END OF ADDENDUM NUMBER ONE (1)

CIVIL PLANS	
CCD PROJECT	23043.10
DATE ISSUED	August 6, 2024
DATE REVISED	August 15, 2024
#	1

CLINTON PARKS - PHASE I
 CITY OF CLINTON
 TRACEWAY PARKS & KIDS TOWNE PARK

OVERALL PLUMBING PLAN - BUILDING 3 (ALTERNATE #3)
 2 P101 1/4" = 1'-0"

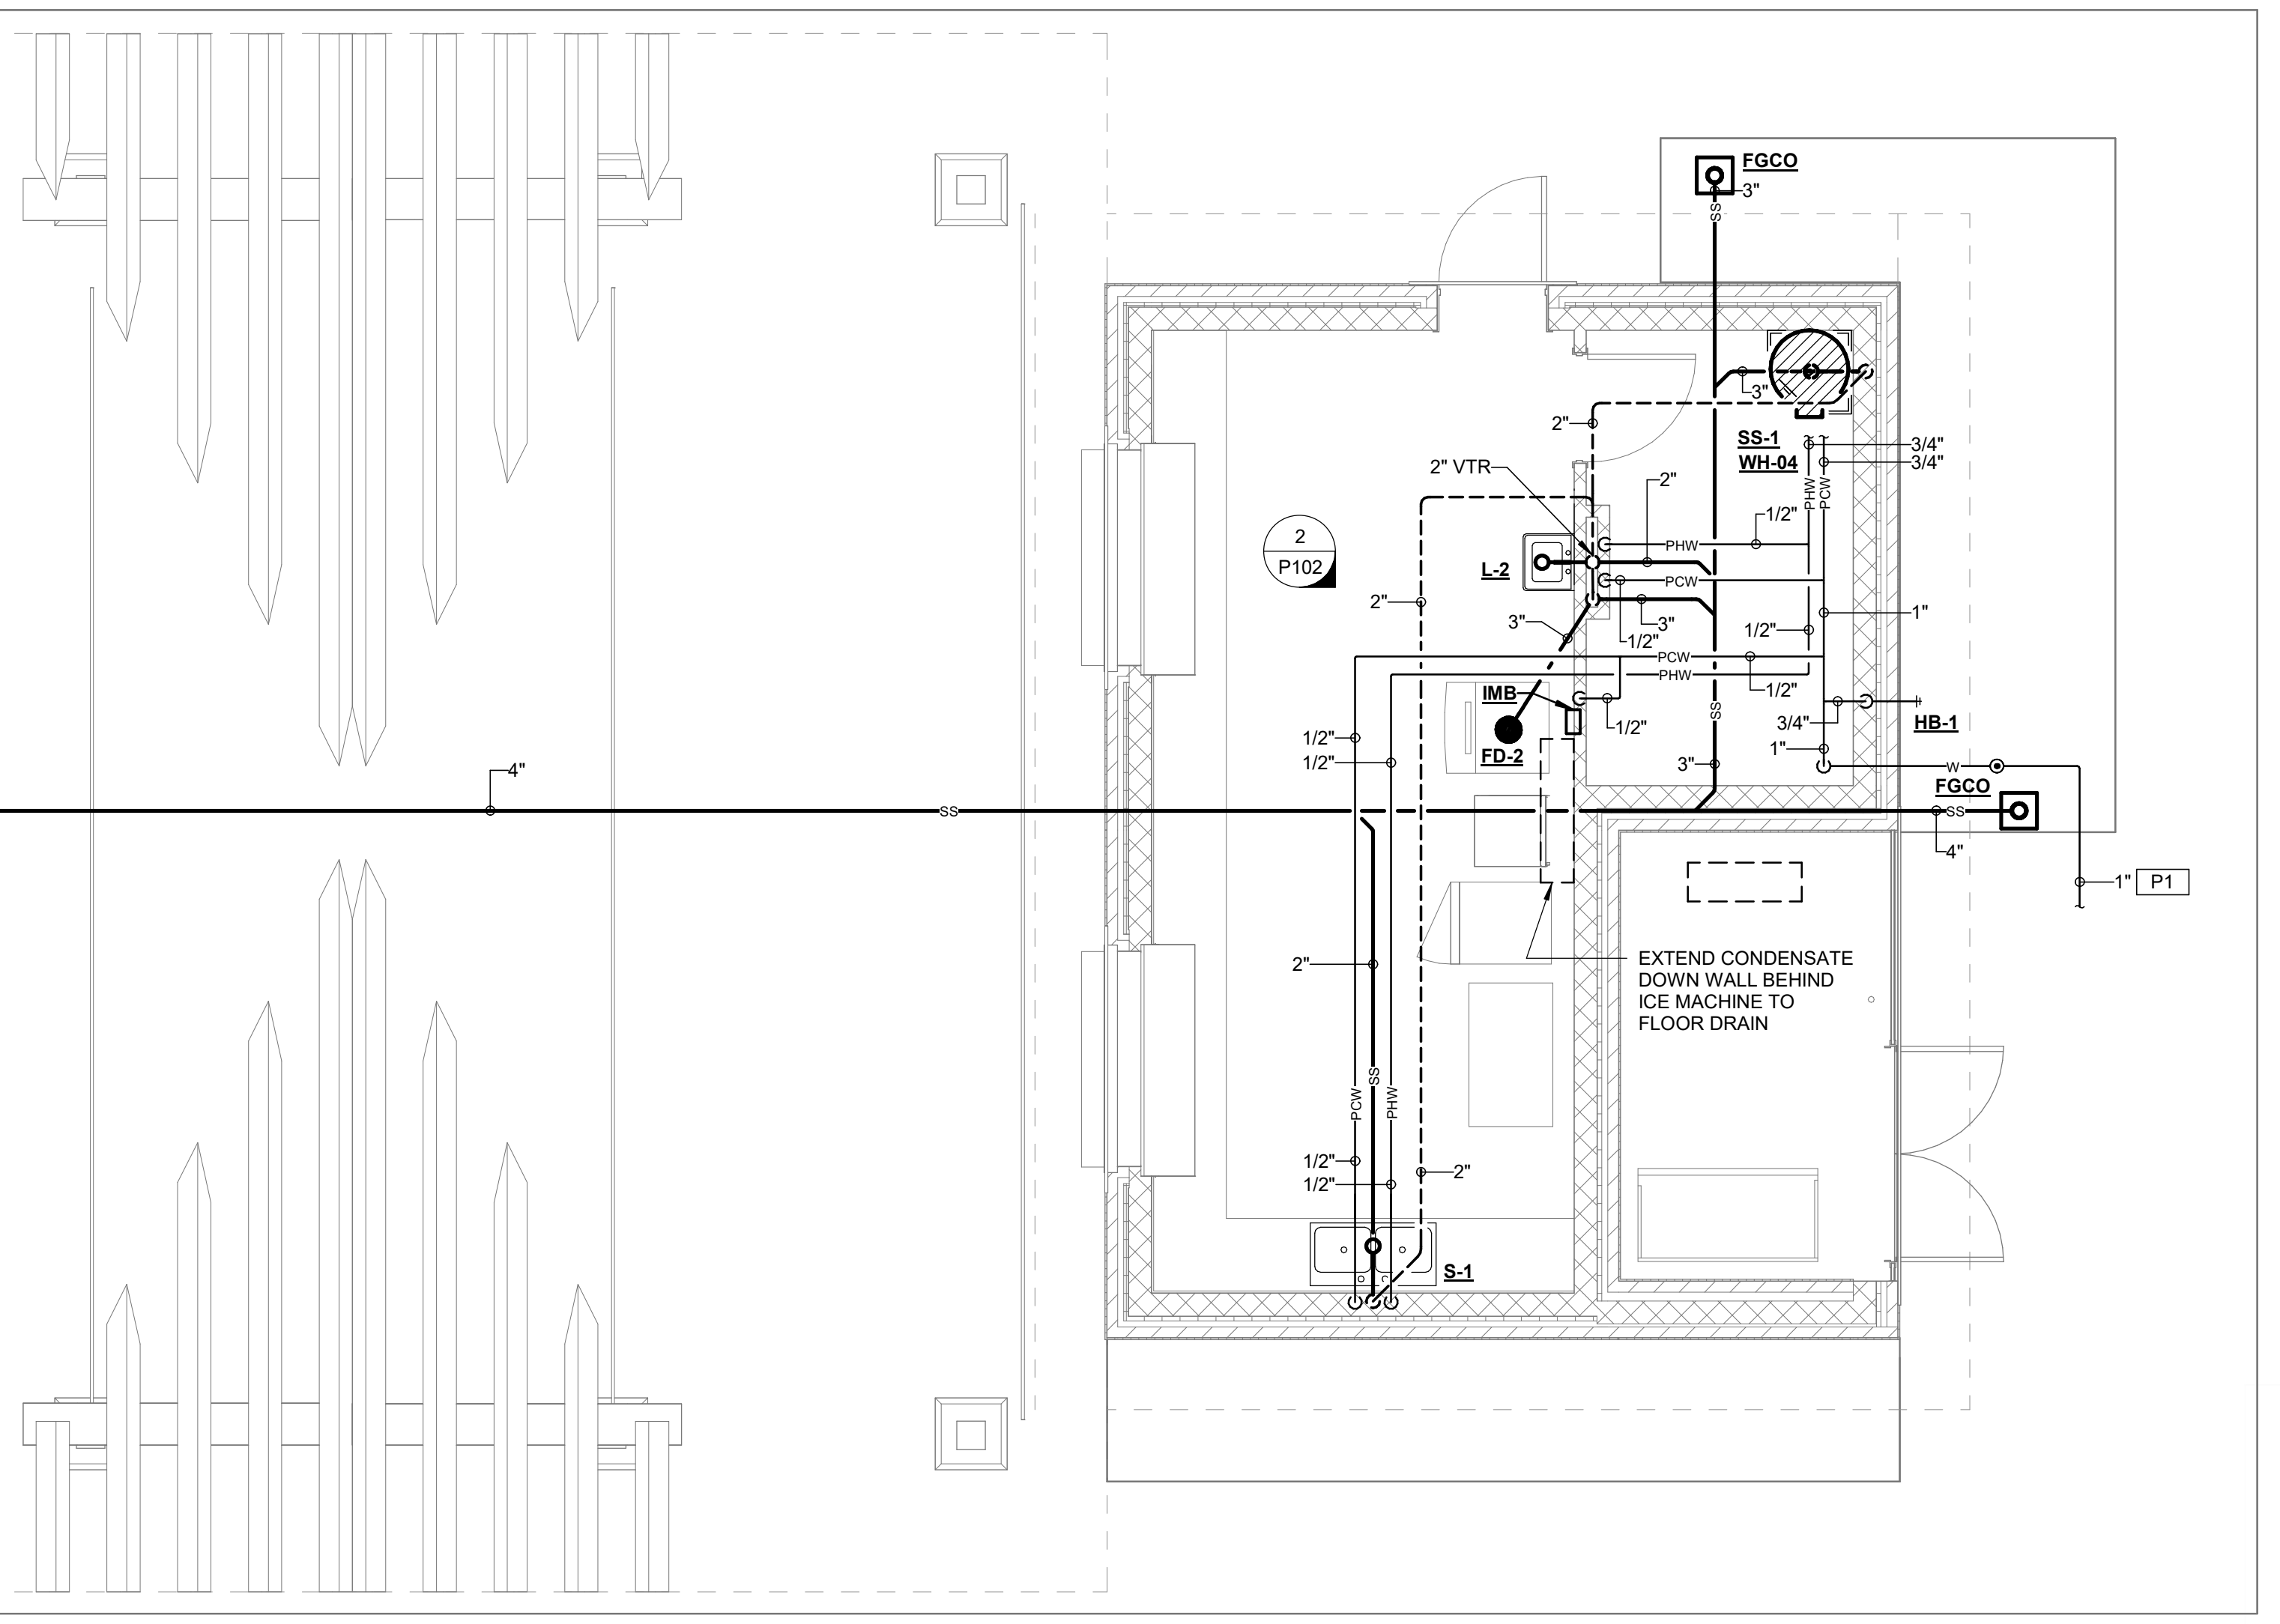
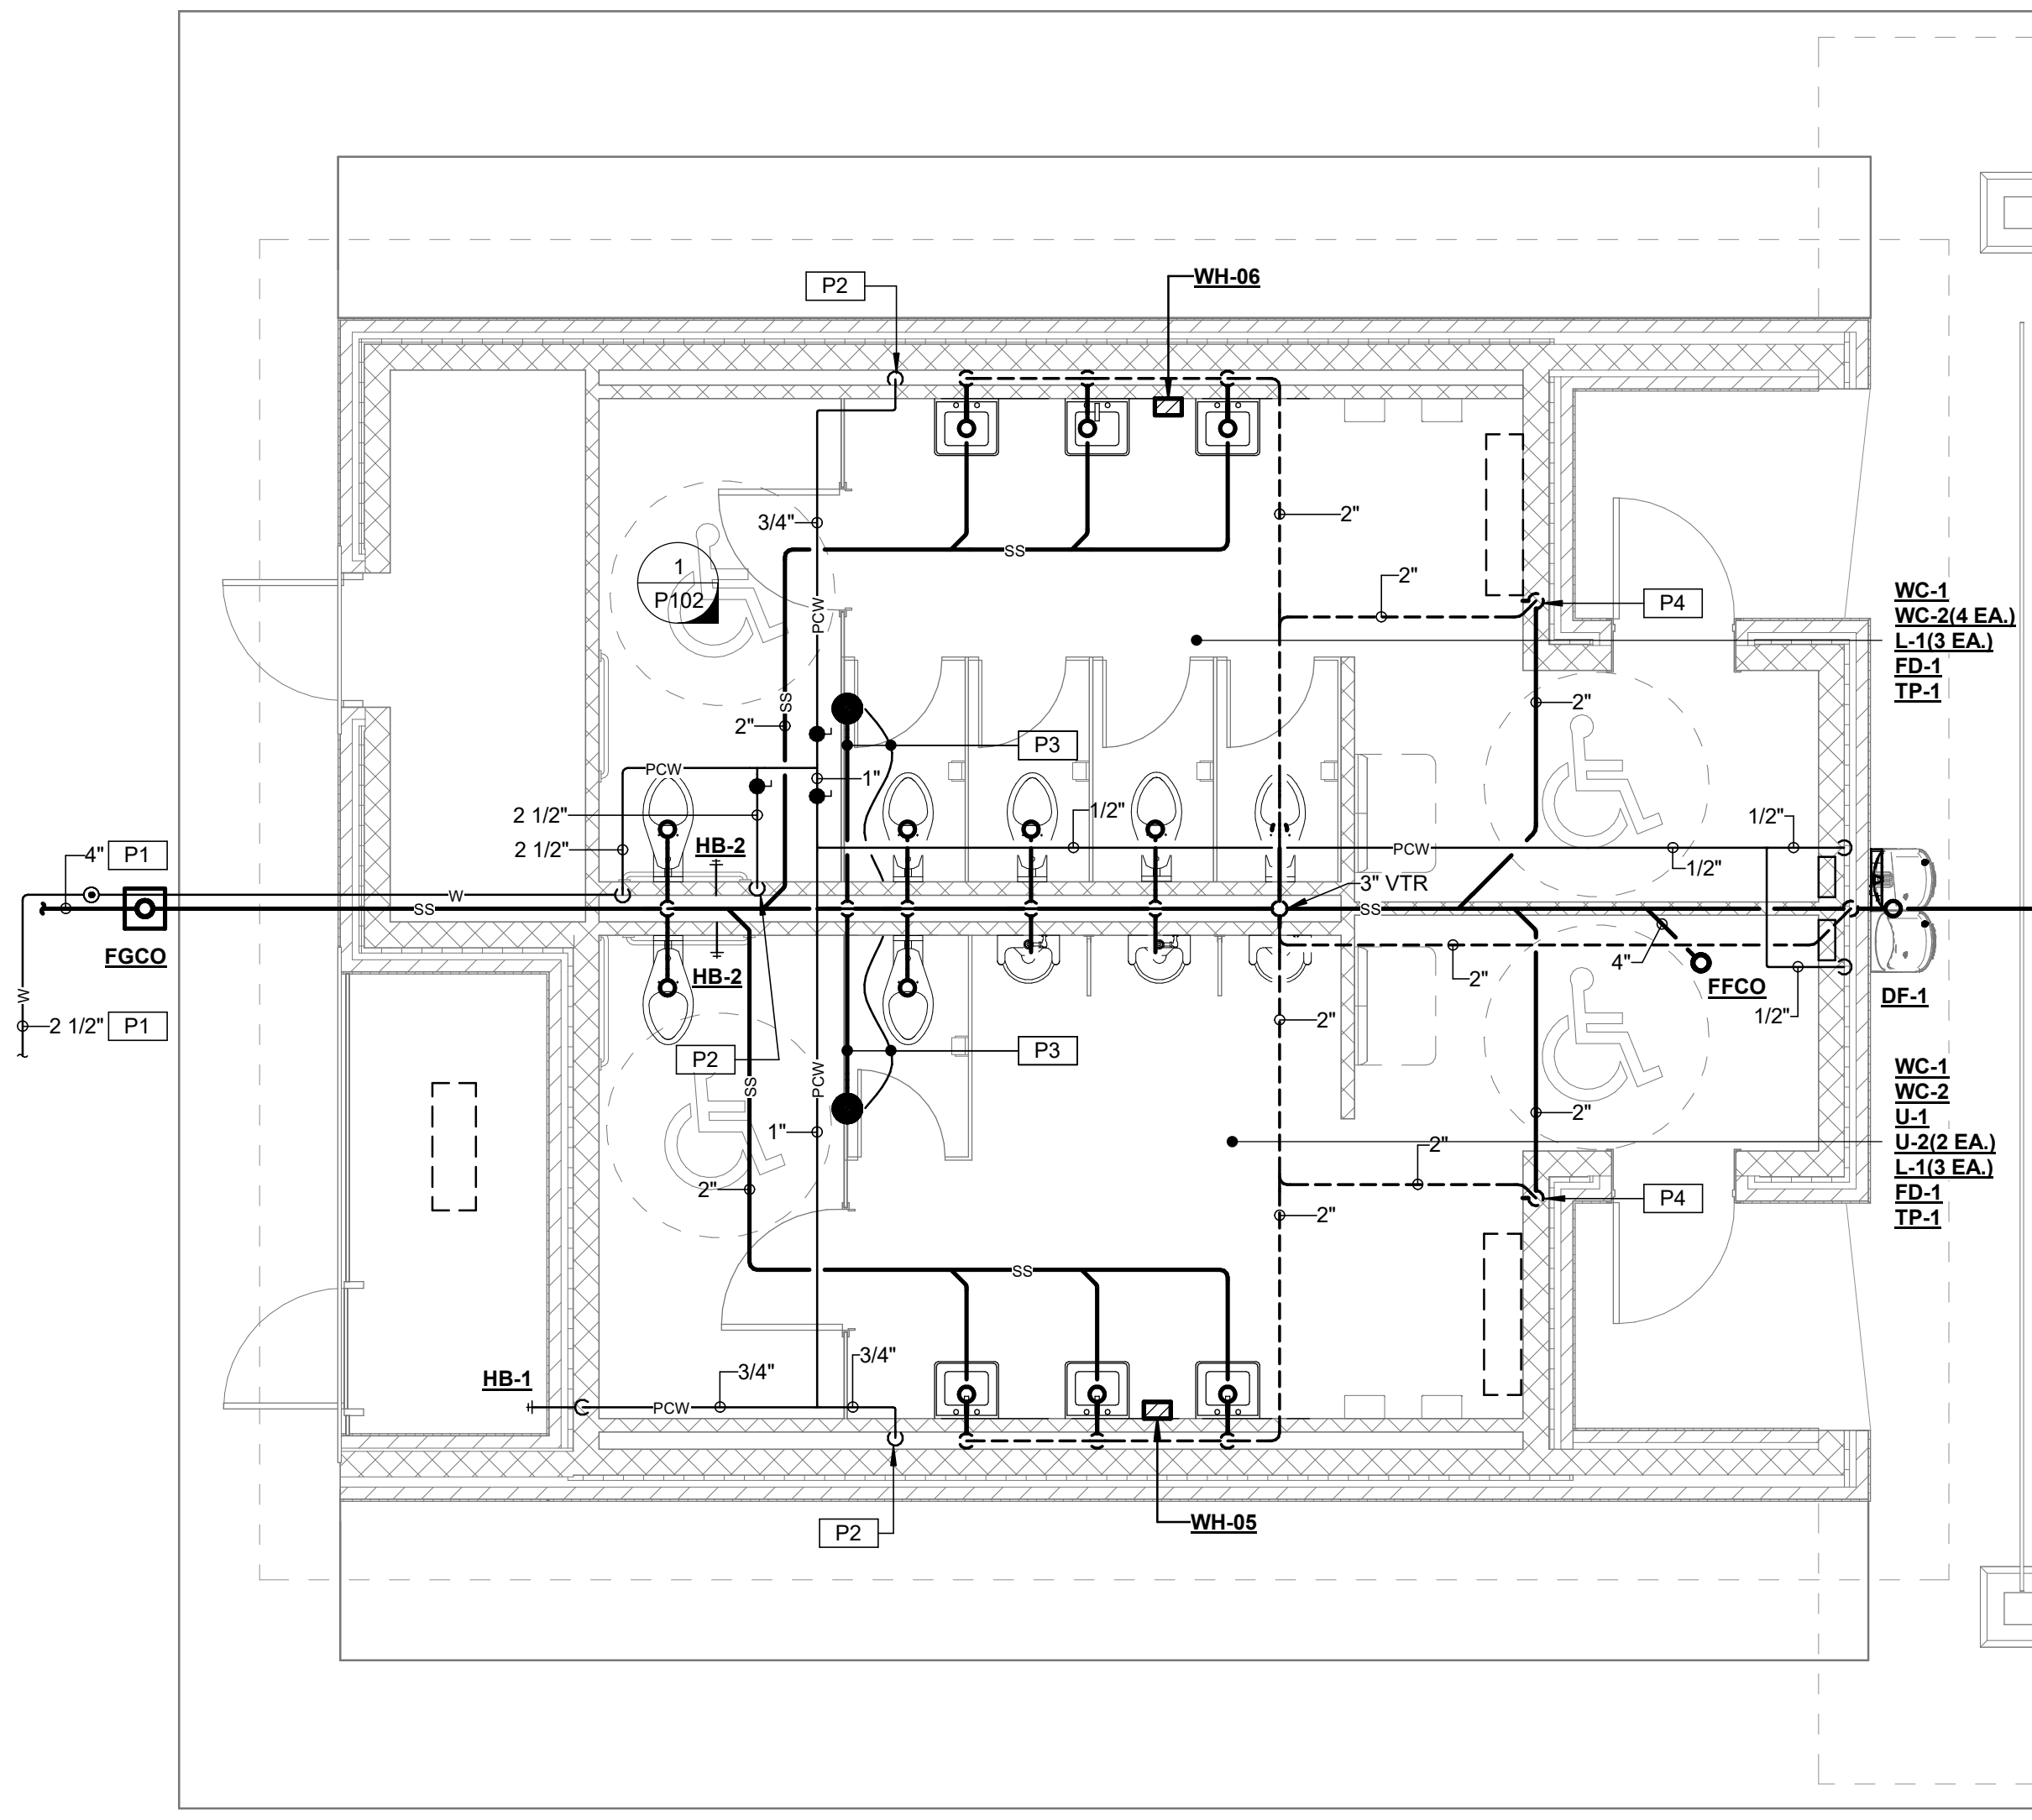
16. **DRAWING P101, PLUMBING PLANS** – Replace with attached P101 R1 dated as revised August 15, 2024.
17. **DRAWING P102, PLUMBING RISERS** – Replace with attached P102 R1 dated as revised August 15, 2024.
